TECHNICAL SERVICE BULLETIN

Part #:	VAR-01012017	Engine:	6.0L Powerstroke & VT365 Navistar
Date:	01/14/2021	Title:	6.0L Variation

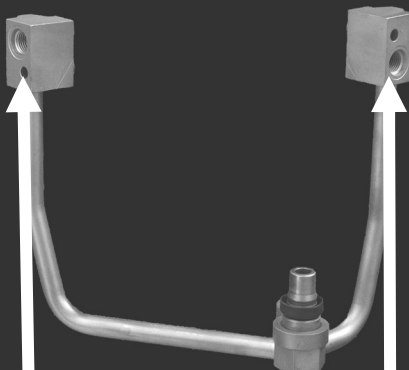
FIRST STYLE BRANCH

THREADED STAND PIPE CONNECTION PART #1840550C1

SECOND STYLE BRANCH

PRESS IN O-RING CONNECTION PART # 1843351C2

THIRD STYLE BRANCH

NEW STYLE HPOP JUNCTION PART # 1843351C3

1ST STYLE INJECTOR CLAMP

2ND STYLE INJECTOR CLAMP

1ST STYLE OIL MANIFOLD

2ND STYLE OIL MANIOLD

PART# 1838901C3, 1838901C4 & OTHERS BOLTS ONTO ROCKER BOX
 # 1840550C1 (1ST)
 # 1843351C2 (2ND)
 # 1843351C3 (3RD)

FORD PART# 1856237C1 & OTHERS BOLTS ONTO ROCKER BOX # 1858473C1 (4TH)

THE FIRST STYLE OIL MANIFOLD ONLY BOLTS CORRECTLY ON TO THE ROCKER BOX PART # 1840550C1

THE SECOND STYLE OIL MANIFOLD BOLTS ONTO ROCKER BOX PART # 1843351C2, # 1843351C3, & # 1858473C1
